UNITED STATES PATENT AND TRADEMARK OFFICE

APPLICATION NO.	FILING DATE	FIRST NAMED INVENTOR	ATTORNEY DOCKET NO.	CONFIRMATION NO.
10/039,060	01/02/2002	Sujat Jamil	42390P12483	9109

Office Action Summary

DETAILED ACTION

Fig. 2

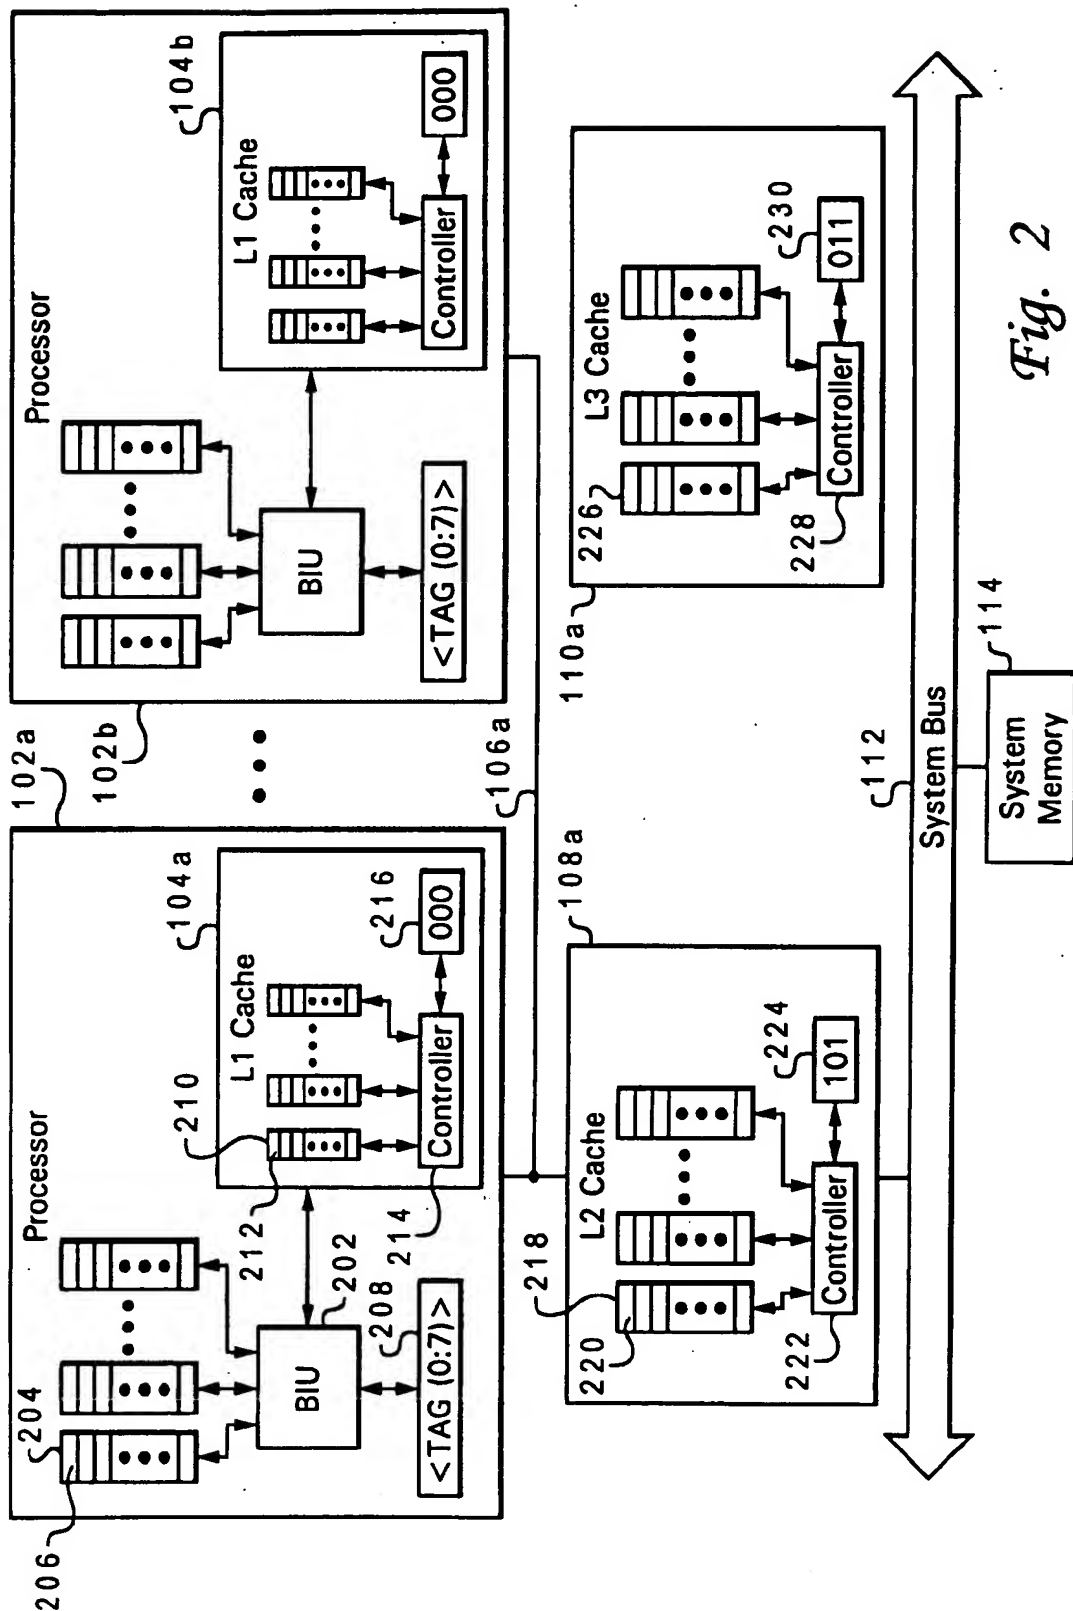
In response, Arimilli states the following at col. 5, lines 59-62 with respect to figure 2:

A cache controller 214 and queues 210 are incorporated within each of L1 caches 104a and 104b to facilitate data access transactions **between** processors 102a and 102b and processor bus 106a.

Fig. 4

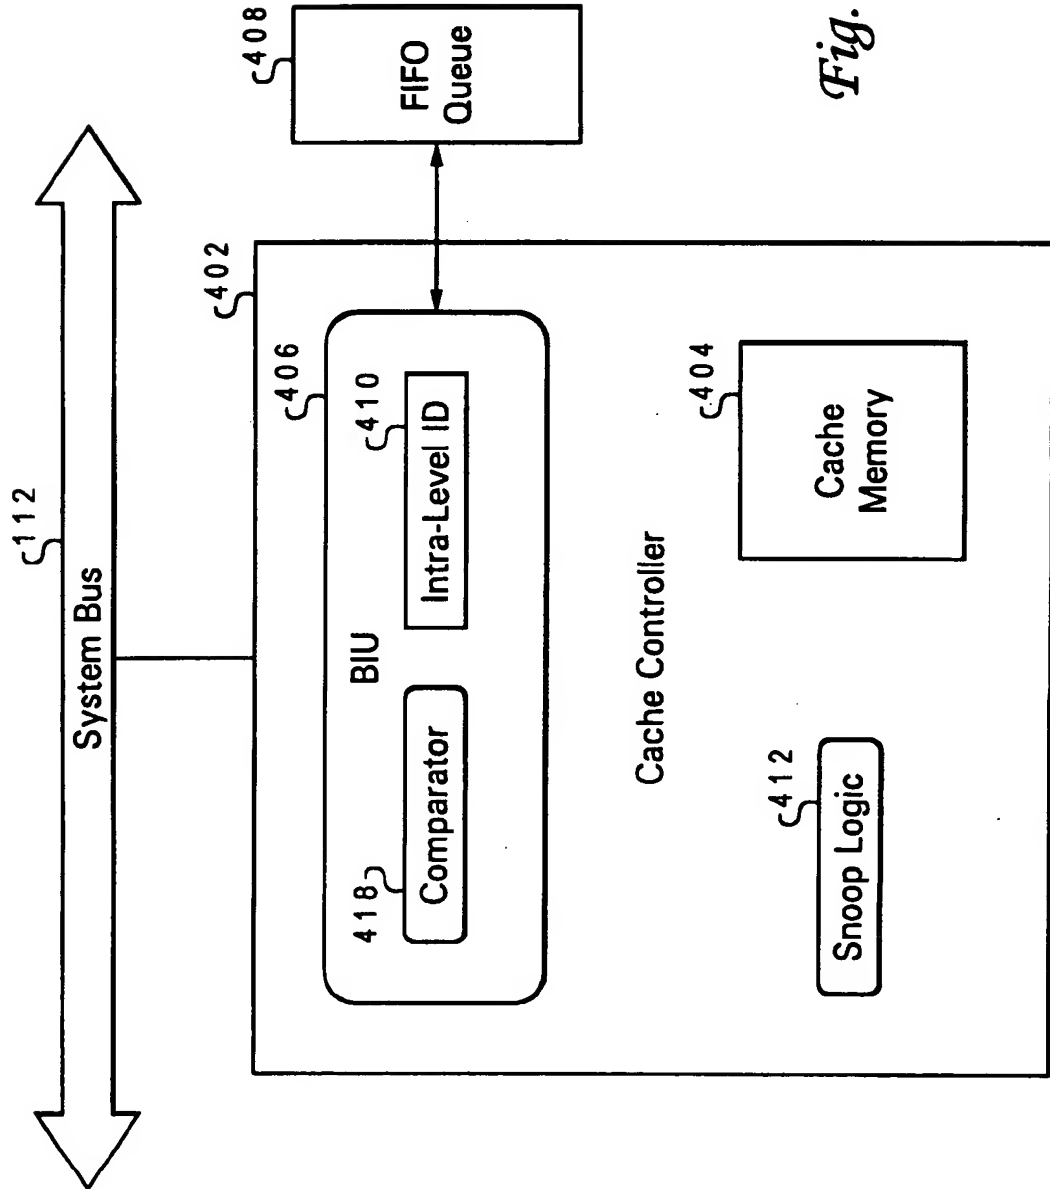
At col. 7, lines 36-43 and lines 51-54; col. 8, lines 38-46 and col. 9, lines 33-45 the following is stated with respect to cache to cache data transfers:

With reference now to FIG. 4, there is illustrated a diagram of a storage device that eliminates the need for reserved vertical queuing of data access requests and provides for enhanced **scarfing** capability... The elements depicted are equally applicable in L2 caches 108a-108b, **L1 caches 104a-104b**, and L3 caches 110a-110n.

Snoop logic 412 detects operations initiated by a **horizontal** storage device (i.e., another L2 cache for L2 caches 108a-108n,)

Given the above disclosure it is clear that snoop logic 412 and/or the cache controller of Arimilli corresponds to the claimed control logic and can transfer data (i.e. cache lines) between dedicated processor L1 caches (104a and 104b, 12a and 12b-n). That is, an L1 cache acting as a

third party transactor can snoop other L1 cache's to scarf data (i.e. transfer data from one cache to another) to maintain coherency (i.e. horizontal cache coherency).
